PEACHTREE CITY PLANNING COMMISSION MEETING

November 11, 2019

REQUEST: Building elevation approval
300 Westpark Drive, Hampton Inn
November 11, 2019 Planning Commission agenda

TO: Planning Commission
VIA: Robin Bechtel Cailloux, AICP Planning and Development Director
FROM: Chandra Wright, Planner
DATE: November 05, 2019
REQUEST: Landscape Plan staff report, 201 Prospect Park, South-Tree Champion Office and Millworks
November 11, 2019 Planning Commission agenda

South Elevation Proposed

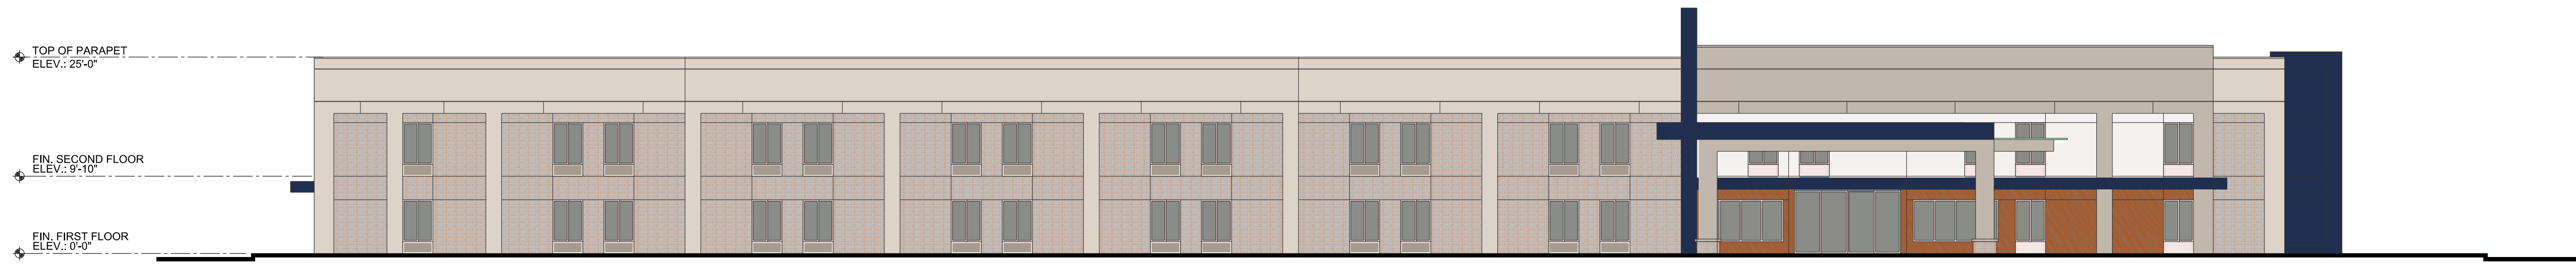
The previous submittal was tabled at the October 24th Planning Commission meeting to allow the applicant to revise the proposal to more closely meet the ordinance standards on an existing building. The applicant has revised the plans to increase the amount of stone on the south façade facing Westpark Drive, as well as the west elevation facing SR 54, and the east elevation facing Commerce Drive.

The proposal will eliminate the mansard roof at the top of the structure and replace it with a parapet. The existing canopy sloped roof will also be removed, and architectural elements added to the canopy area to emphasize the main entrance. A wood-look panel and stone veneer around pedestrian entrances also provide visual cues to the main entrance. An updated neutral paint selection with navy blue accents will complete the updated appearance.

While the ordinance recommends at least 80 percent brick or stone on front facades and 50 percent brick or stone on side facades, the existing building does not have any masonry or stone elements. The revised proposal to add stone accents to the front (estimated 50%) and side elevation (estimated 30%) brings the building closer to complying with the standard.

Staff has worked with the applicant and the Planning Commission representative to increase the amount of masonry on the building. Staff is of the opinion that the revised proposal increases the amount of stone, thereby improving the existing conditions of the building and recommends approval.

LANDSCAPE PLAN

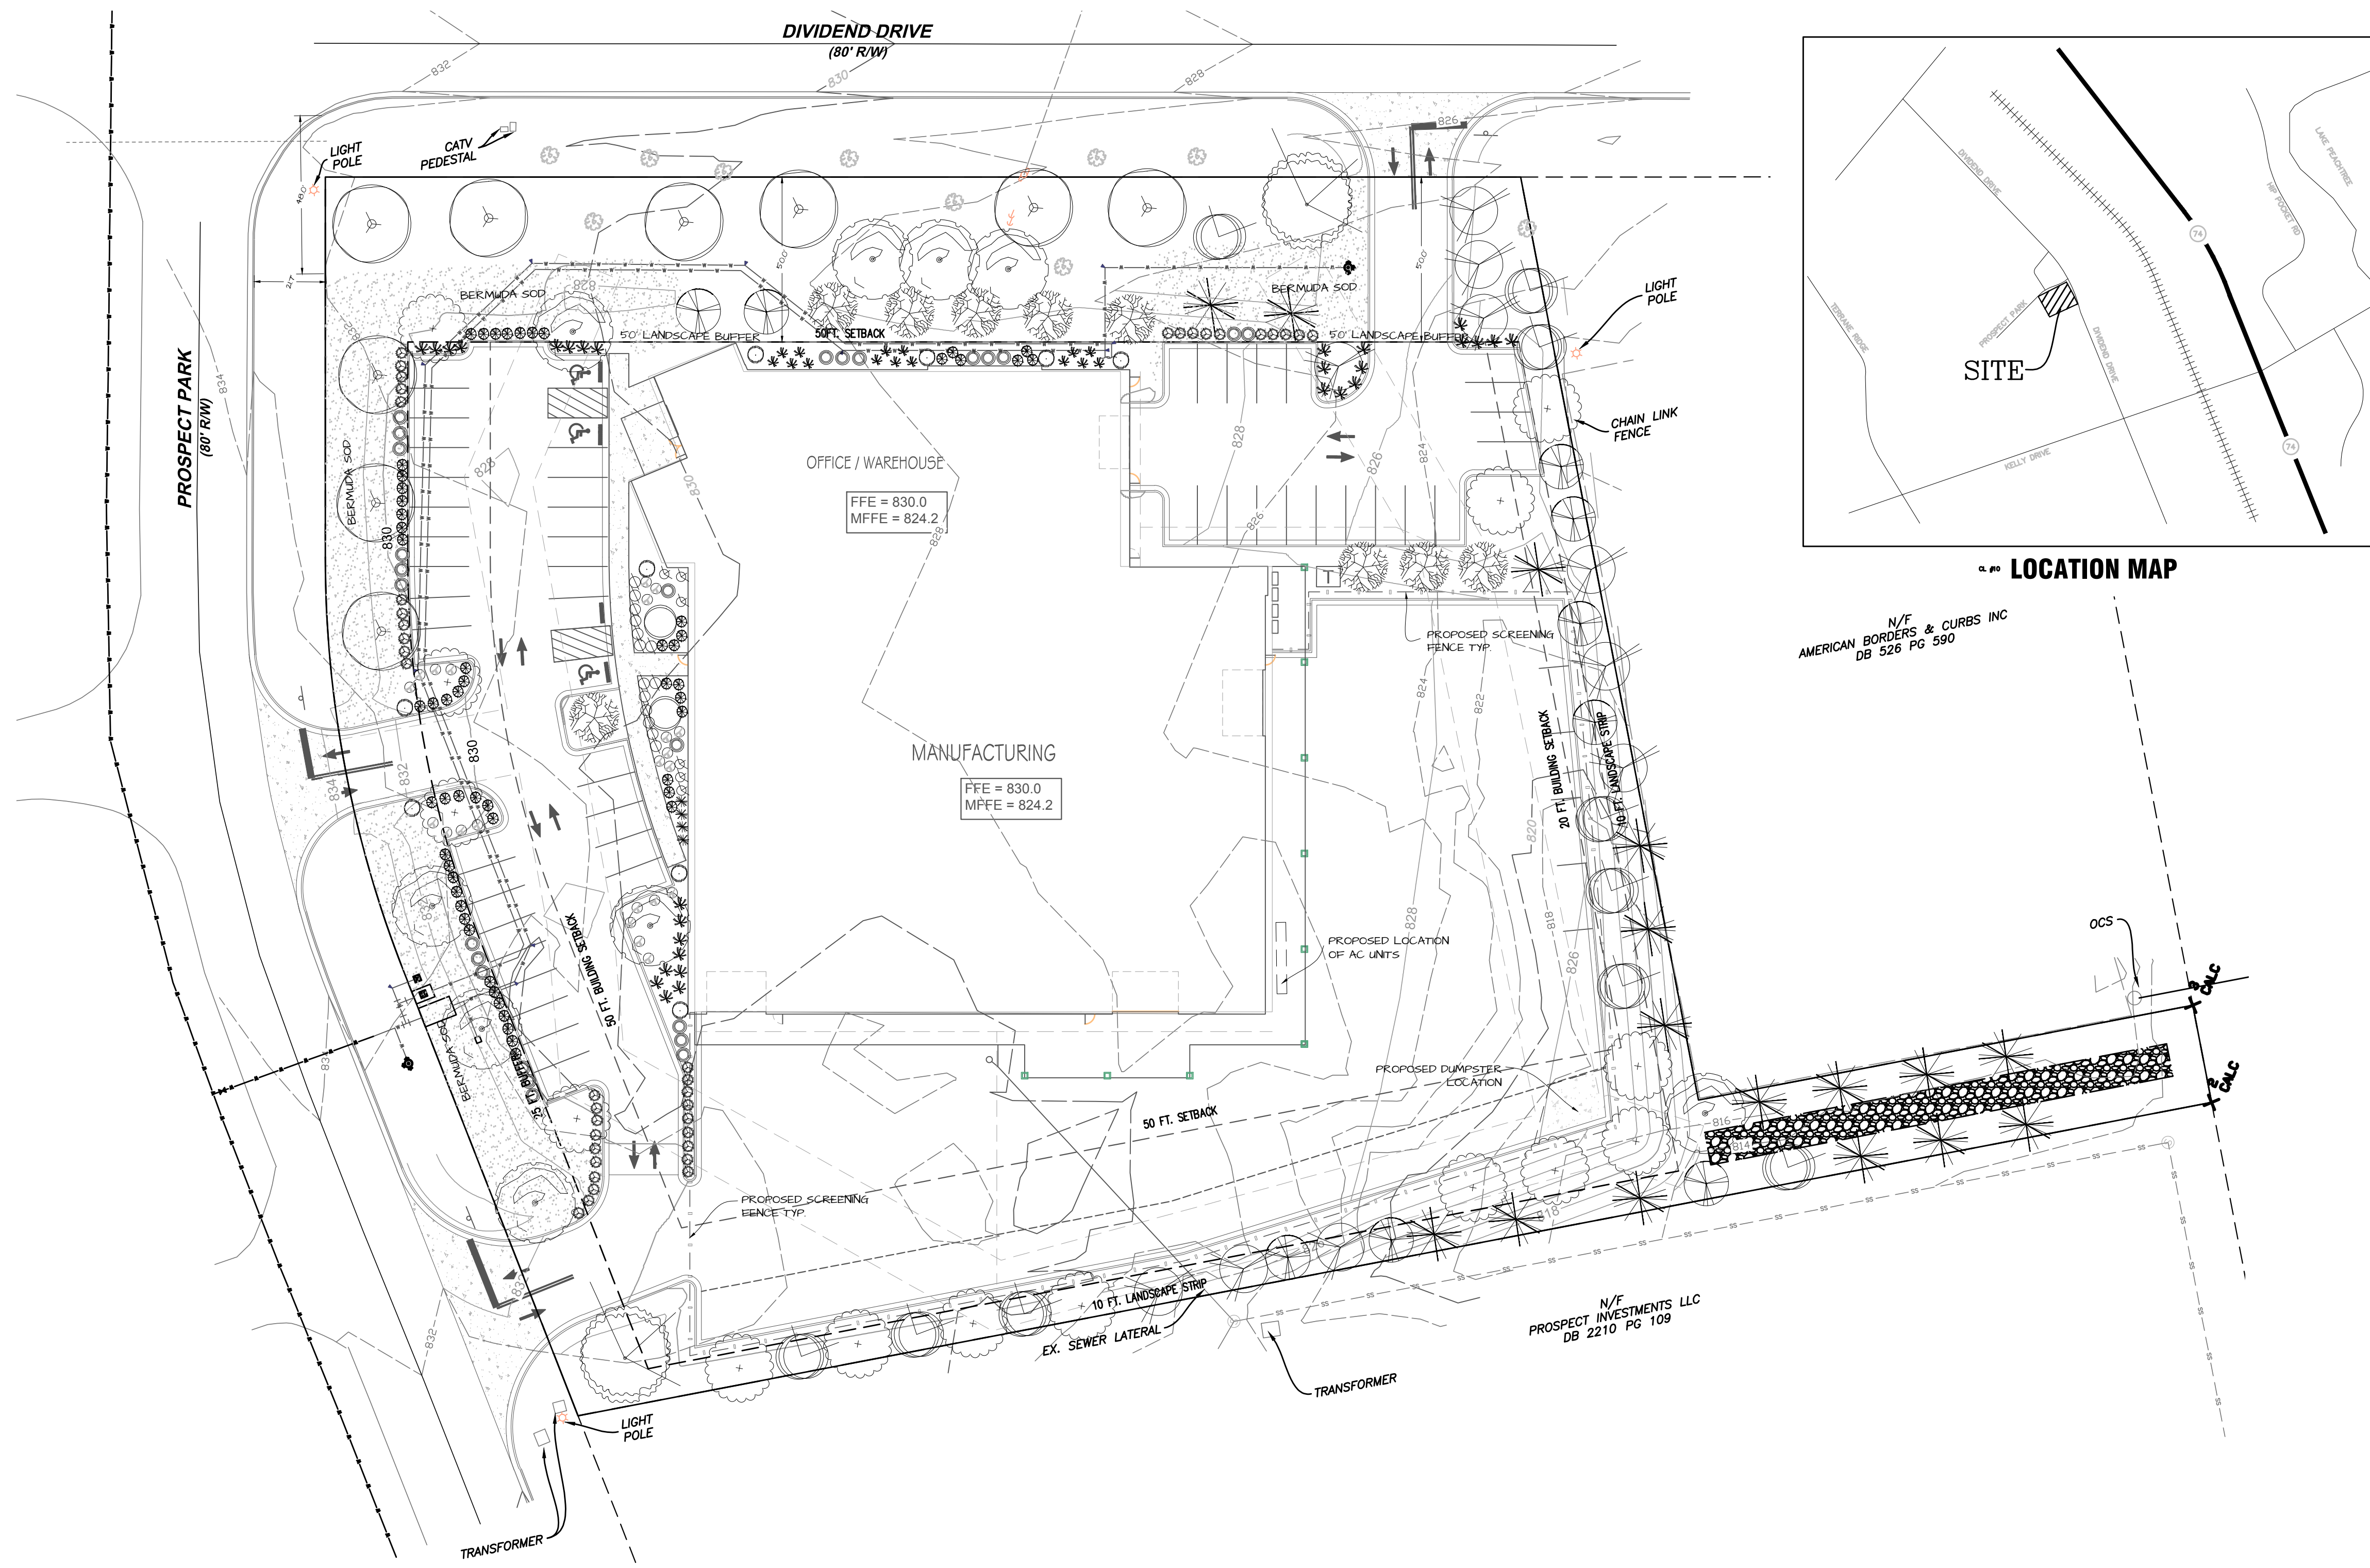
The site is located along Dividend Drive, which is classified as a community collector. Per Section 723.1 of the Land Development Ordinance (LDO), a 50-foot landscape buffer is required along a community collector. This buffer is provided adjacent to Dividend Drive, with the applicant planting additional plant material in the buffer.

The applicant is requesting to use the Tree Fund alternative compliance option, which requires that at least 50% of the required tree inches be planted on the property. The plan proposes to plant 220" of the required 438", meeting the 50% requirement.

The parking lots fronting Dividend Drive and Prospect Park are both surrounded by evergreen bushes that will grow to at least 24" in height, meeting the requirements of the LDO Section 1108. Staff is of the opinion that the proposed landscape plan meets the Landscape Plan requirements of the City ordinances and recommends approval with the following conditions:

- All utility equipment must be screened with evergreen plant material.
- All HVAC and other mechanical equipment must be screened by an opaque wall or fence and/or evergreen plant material.

LANDSCAPE PLAN

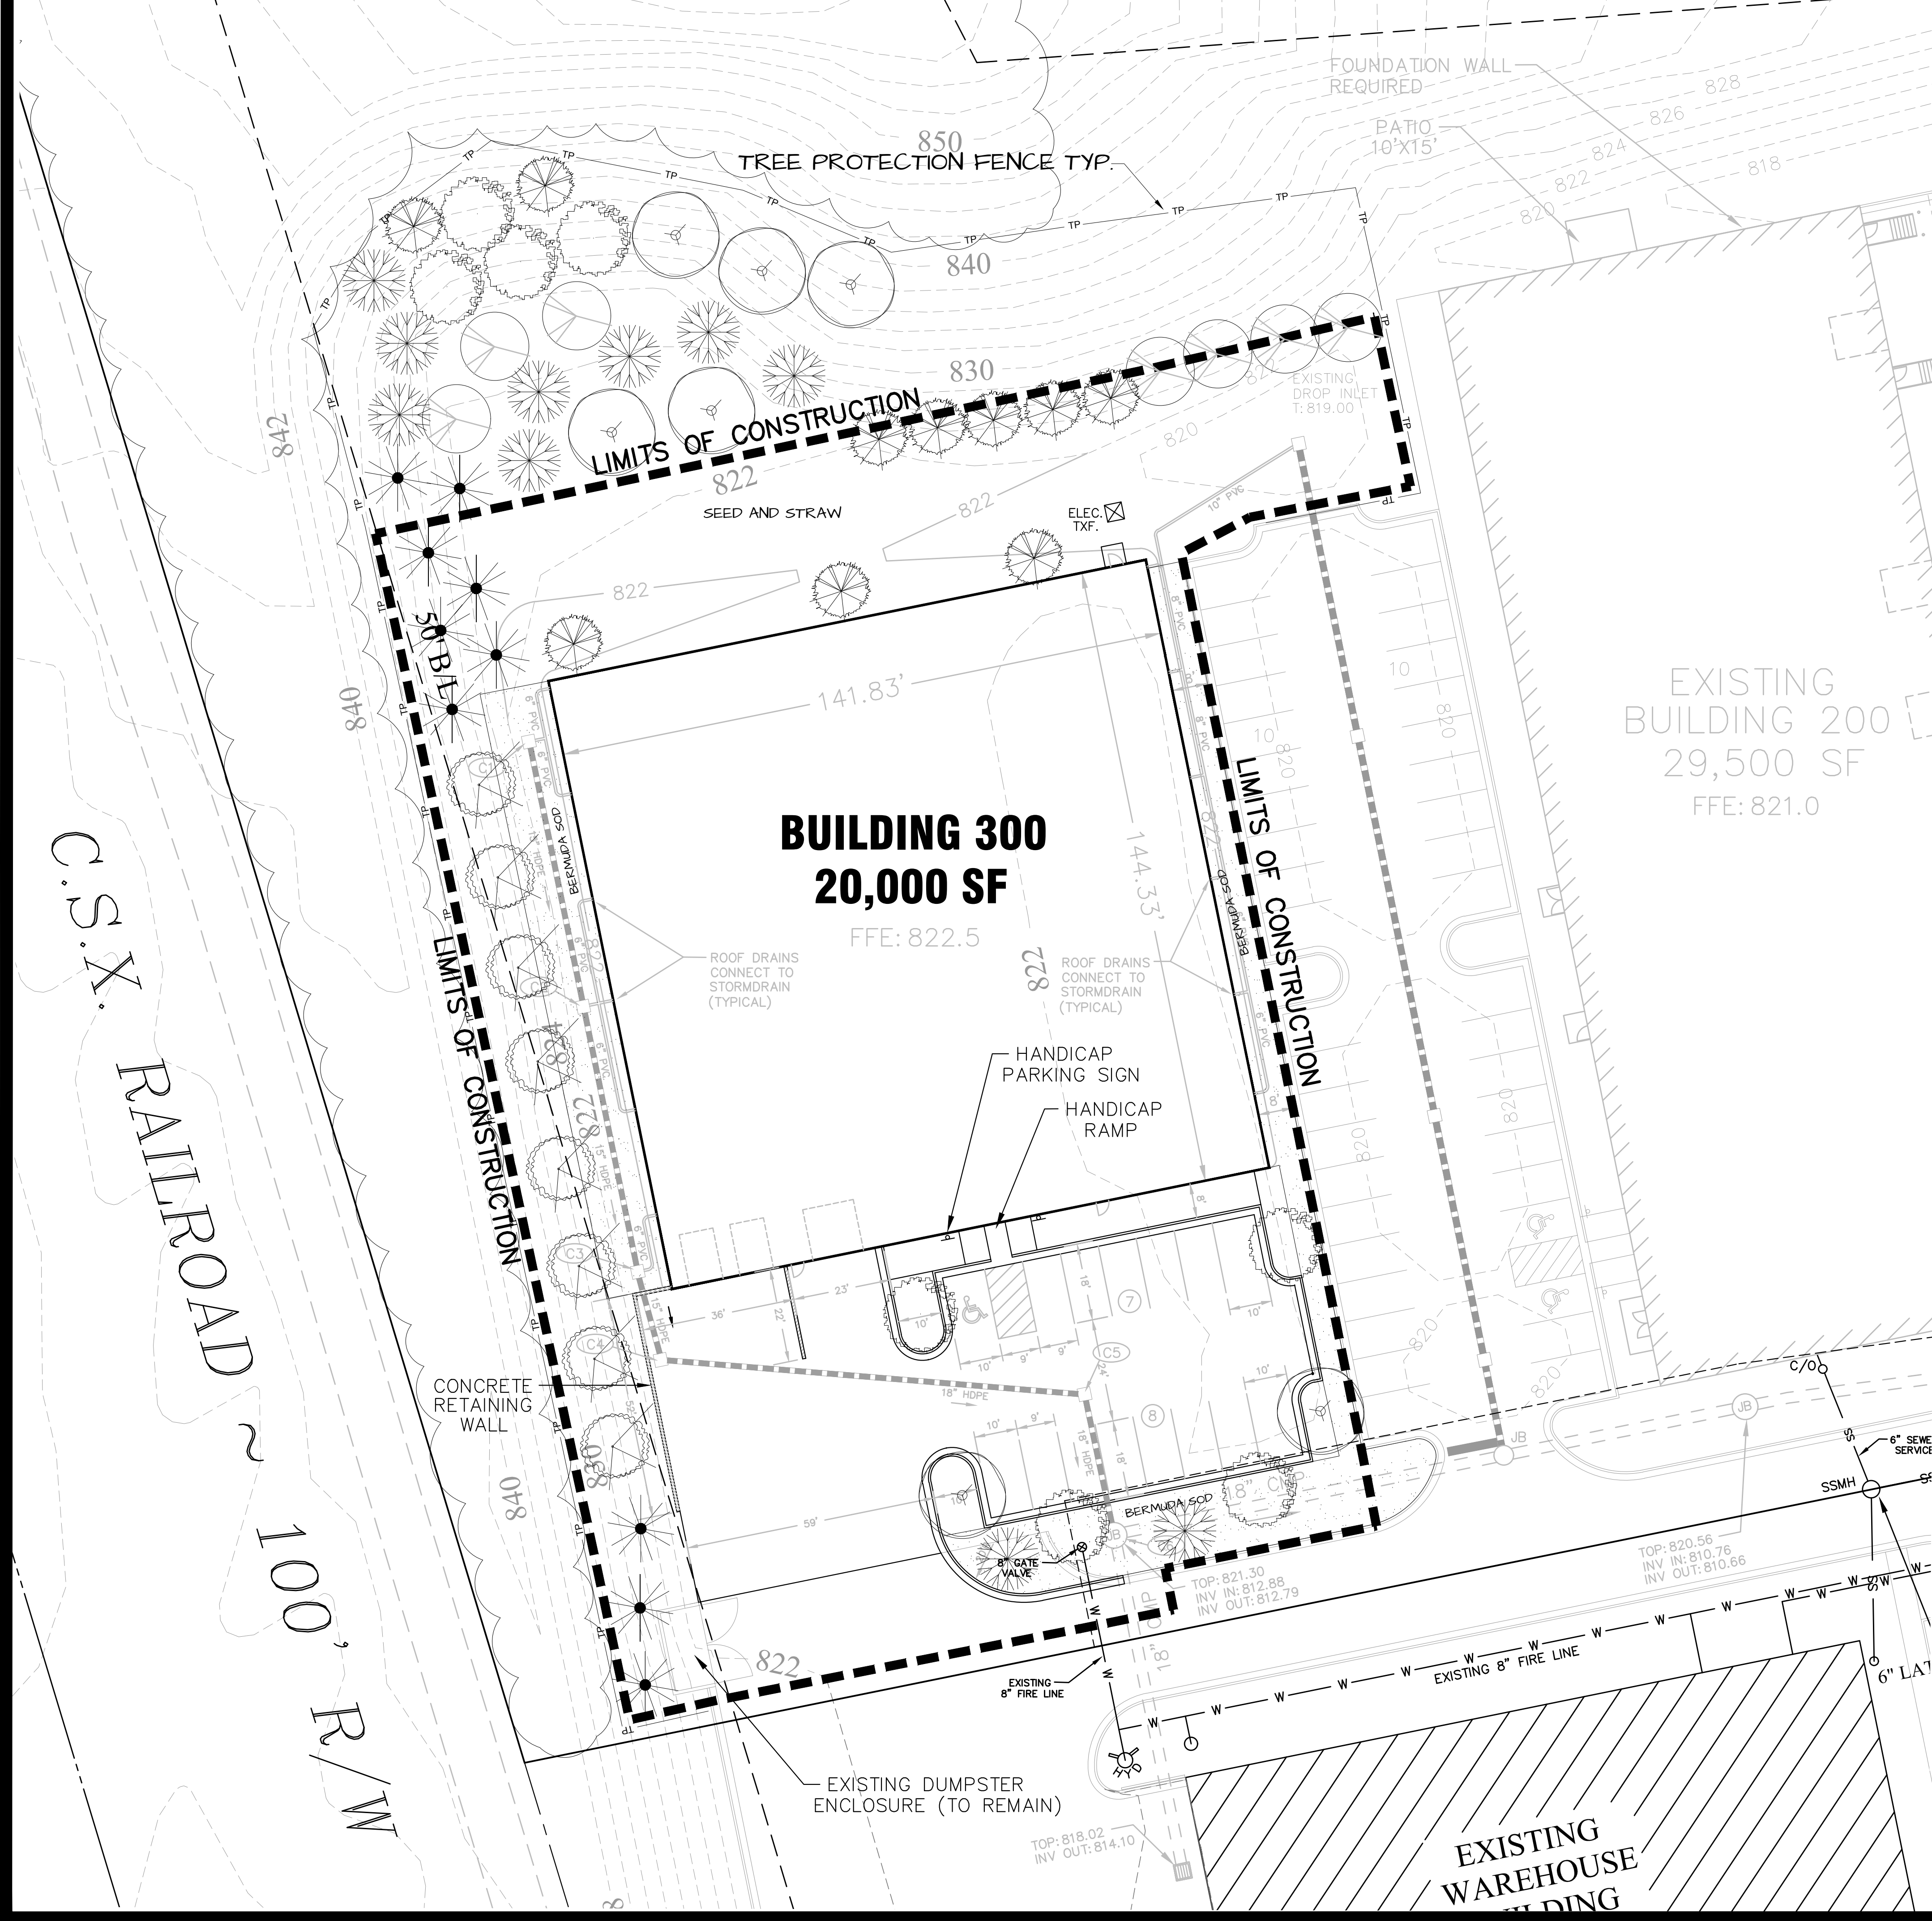
The plan proposes to plant on the property 90" of canopy trees and 60" of understory trees, meeting ordinance requirements.

Landscape design for previous phases of this project was provided by another landscape architect. It is expected that design for this phase will be complimentary. Staff is of the opinion that the proposed landscape plan meets the Landscape Plan requirements of the City ordinances and recommends approval.

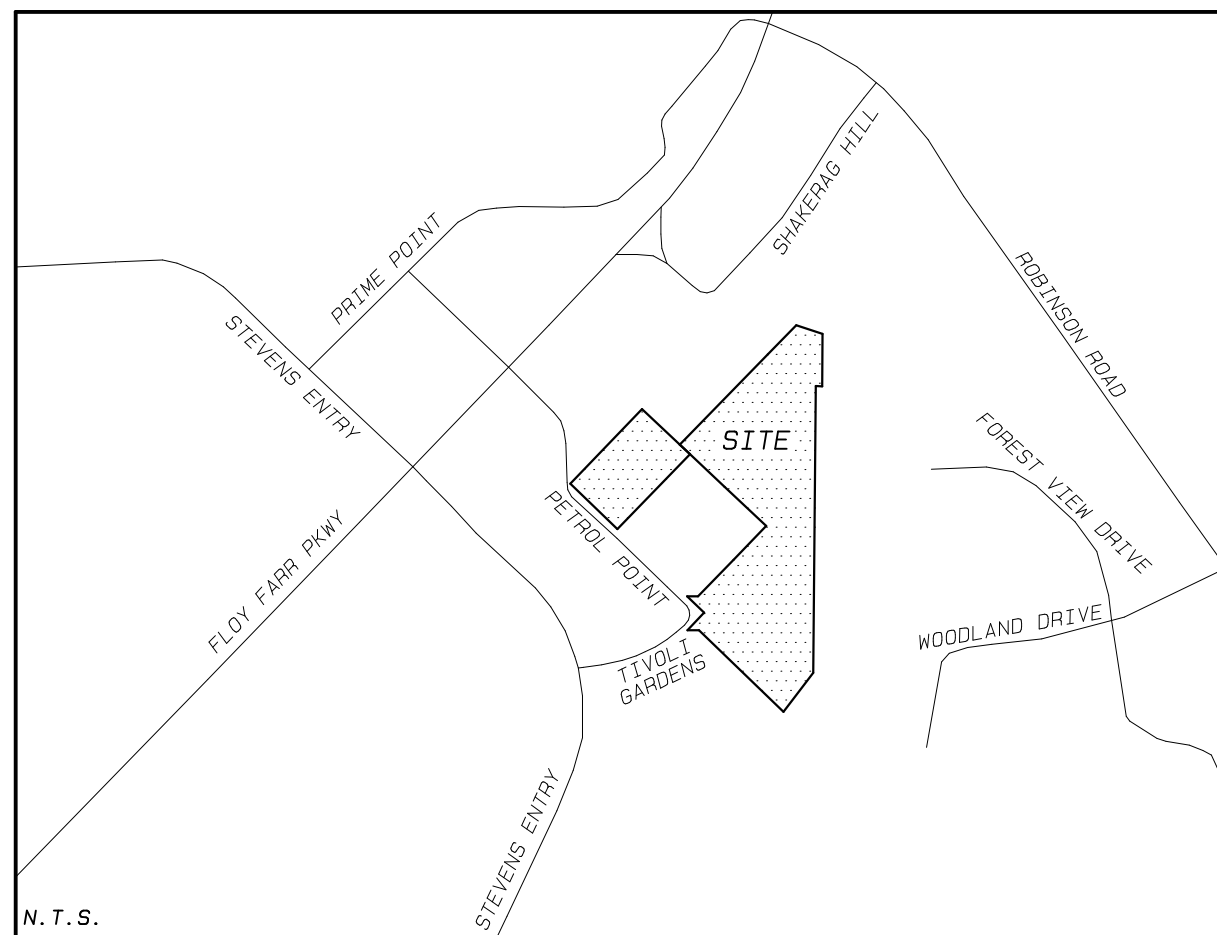
The conceptual plat and conceptual site plan are nearly identical to the master plan as approved in the rezoning. The street configuration on the northern portion of the residential area has been simplified and the single-family lot layout has been regularized from the master plan (see Figure 1). This is not a significant change.

The existing multi-use path encroaches onto the northern portion of this property. Two path connections are shown on the western property line. A third connection to the north is labeled on the as an easement or possible greenspace to be dedicated to the City for possible connections to the Shakerag Hill commercial office park in the future.

The commercial portion must also comply with the conceptual site plan requirements provided for in the Land Development Ordinance (LDO). The site is not within 500 feet of a major thoroughfare, and therefore does not have to provide a landscape/tree-save buffer along Petrol Point. A commercial building elevation review step is not required by either the LDO or the zoning conditions. Staff will ensure that commercial elevations comply with the architectural scheme during the building permit phase of development.
